ENVIRONMENTAL REVIEW COMMITTEE REPORT

ERC MEETING DATE:	August 25, 2014
Project Name:	Renton Technical College Automotive Complex Renovation
Project Number:	LUA14-000997
Project Manager:	Kris Sorensen, Associate Planner
Owner:	Renton Technical College
Applicant:	Matt Lane, McGranahan Architects; 2111 Pacific Ave #100; Tacoma WA 98402
Contact:	Barry Baker, Facilities Manager; RTC; 3000 NE 4 th St; Renton WA 98056
Project Location:	Building K Complex (Automotive Complex) of Renton Technical College Campus at 3000 NE 4 th St

1 TREE INVENTORY PLAN
SCALE: 1" = 100'-0"

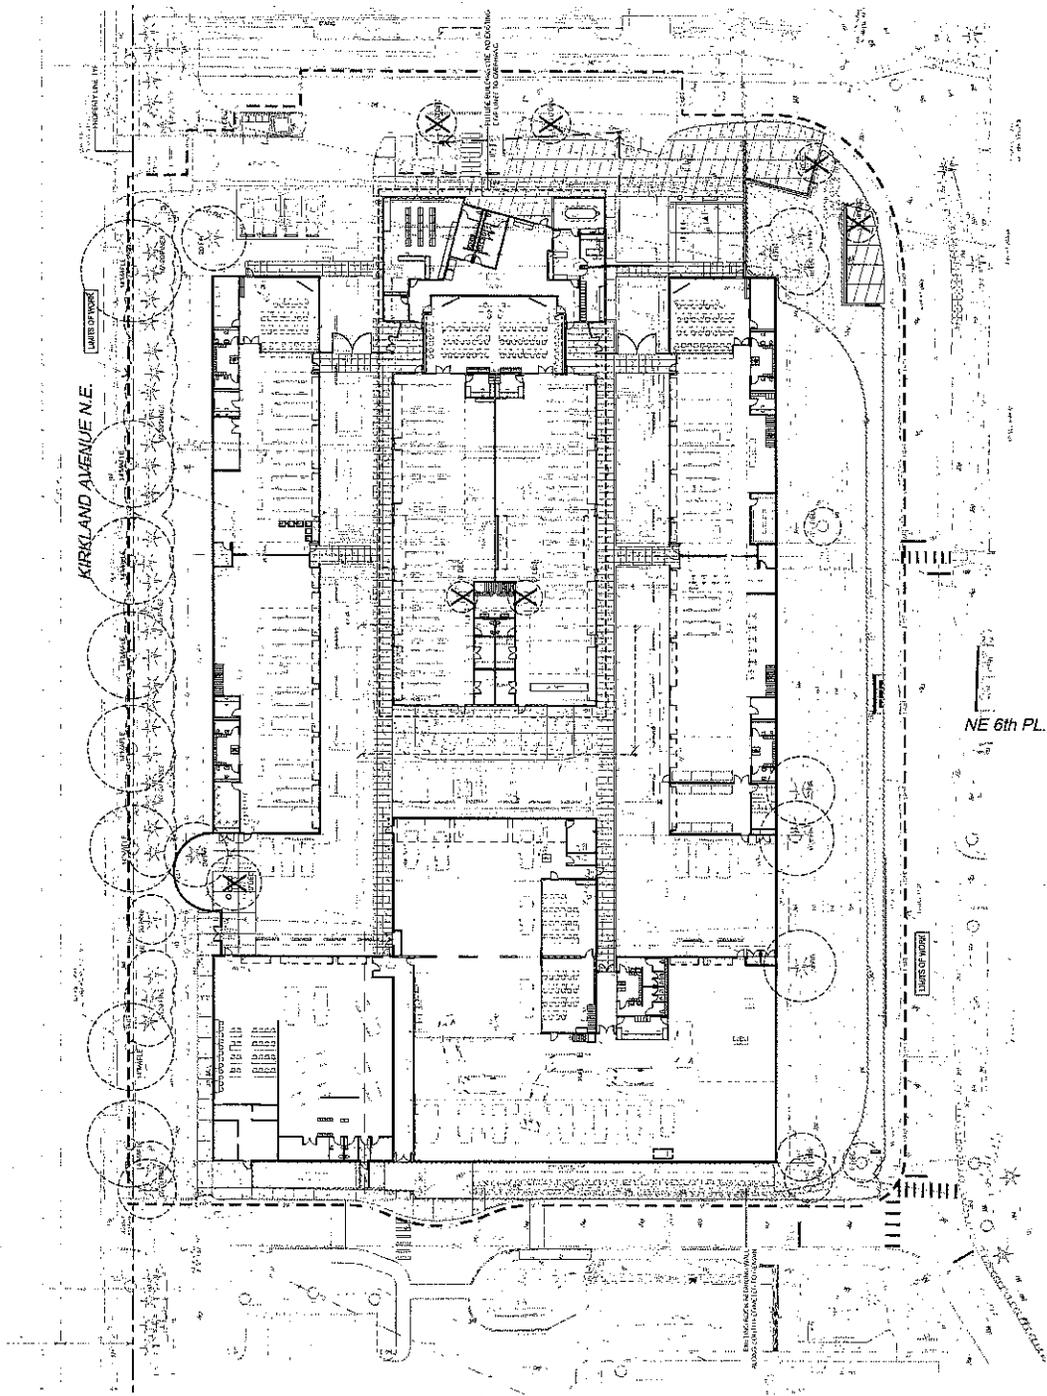
4. A National Permit Discharge Elimination System (NPDES) permit is required when more than one acre is being cleared.
6. The applicant may not fill, excavate, stack or store any equipment, dispose of any materials, supplies or fluids, operate any equipment, install impervious surfaces, or compact the earth in any way within the area defined by the drip line of any tree to be retained.

7. The applicant shall erect and maintain six foot (6') high chain link temporary construction fencing around the drip lines of all retained trees, or along the perimeter of a stand of retained trees. Placards shall be placed on fencing every fifty feet (50') indicating the words, "NO TRESPASSING – Protected Trees" or on each side of the fencing if less than fifty feet (50'). Site access to individually protected trees or groups of trees shall be fenced and signed. Individual trees shall be fenced on four (4) sides. In addition, the applicant shall provide supervision whenever equipment or trucks are moving near trees.
